## REMARKS

In the Office Action mailed August 11, 2003:

FIG. 1

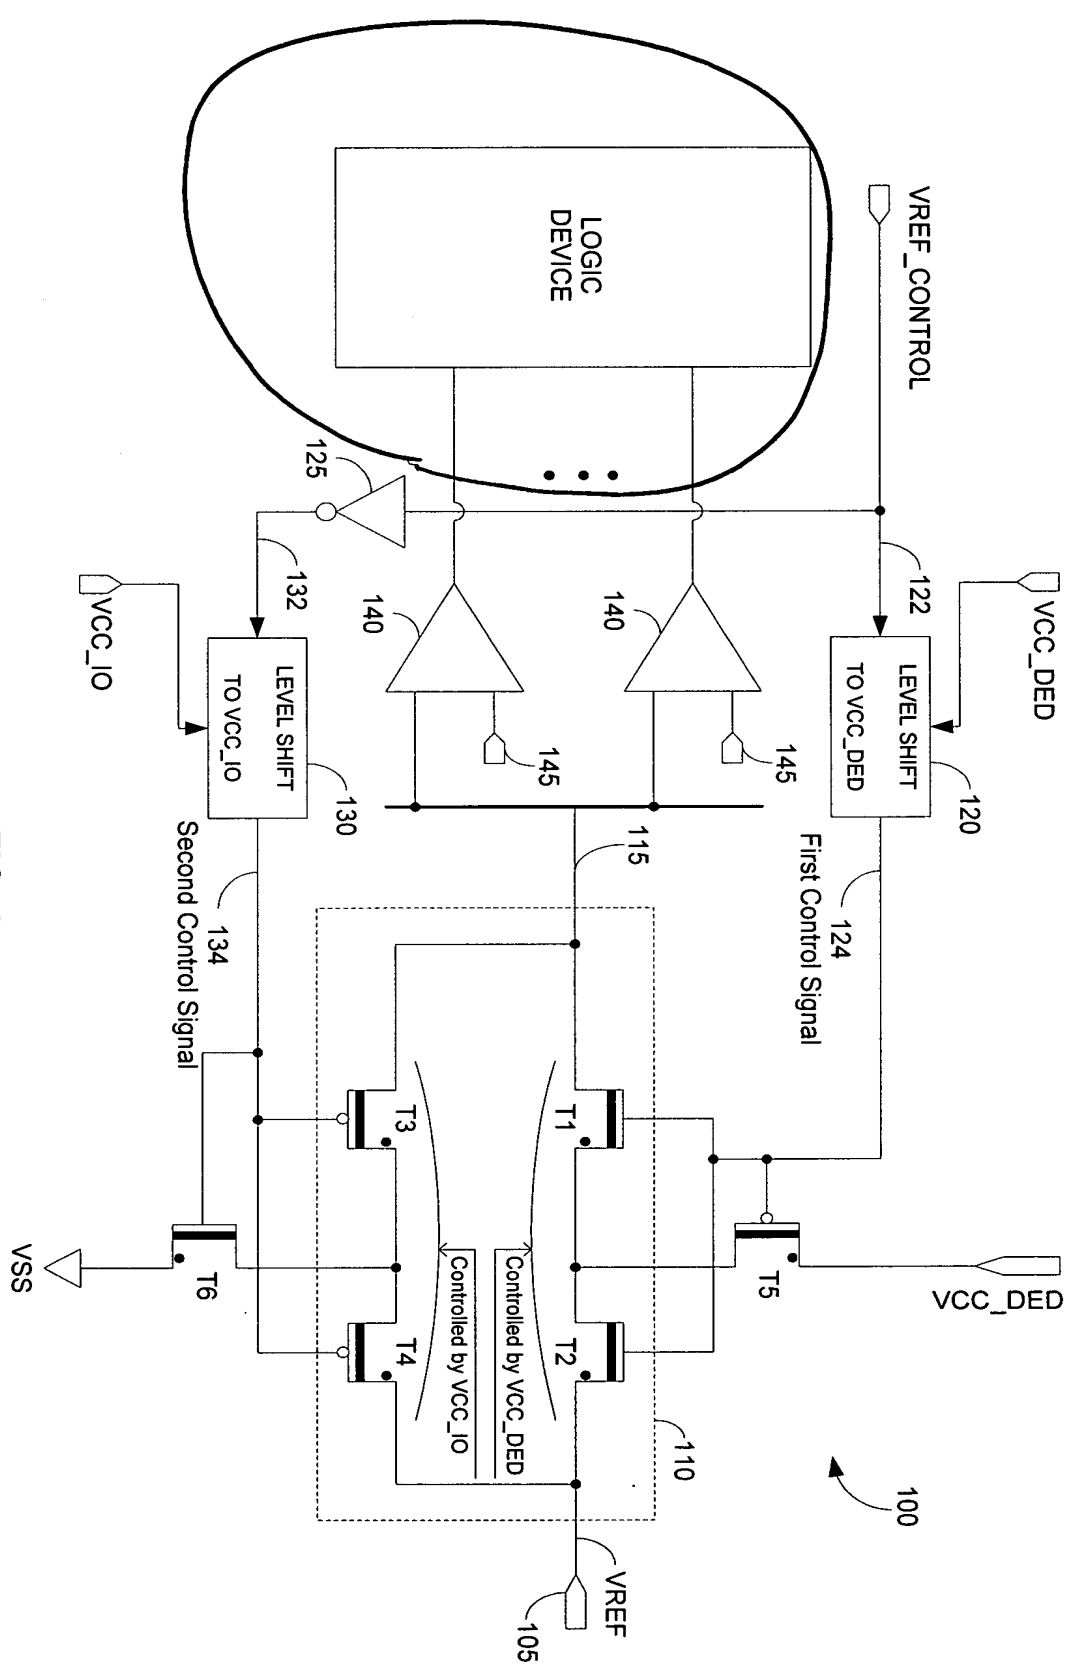
The Examiner also contends that claims 11 and 20 appear to be misdescriptive because Fig. 1 shows that the master control signal (VREF\_CONTROL) is unrelated to the logic device (140) and that the limitation "the first supply signal is a core supply signal" in claim 11 makes no sense because "the first supply signal" and "the master control signal" refer to the same entity as recited on lines 2-3 of claim 8.

Element 140 is an input buffer that supplies signals to the logic device. To clarify this, Fig. 1 has been amended as circled in red to add a box labeled "logic device". This amendment is supported by the specification at page 6, line 31. Claims 8 and 11 have been amended to delete the reference to the first supply signal and to specify in claim 11 that the logic level is determined by a core supply signal.
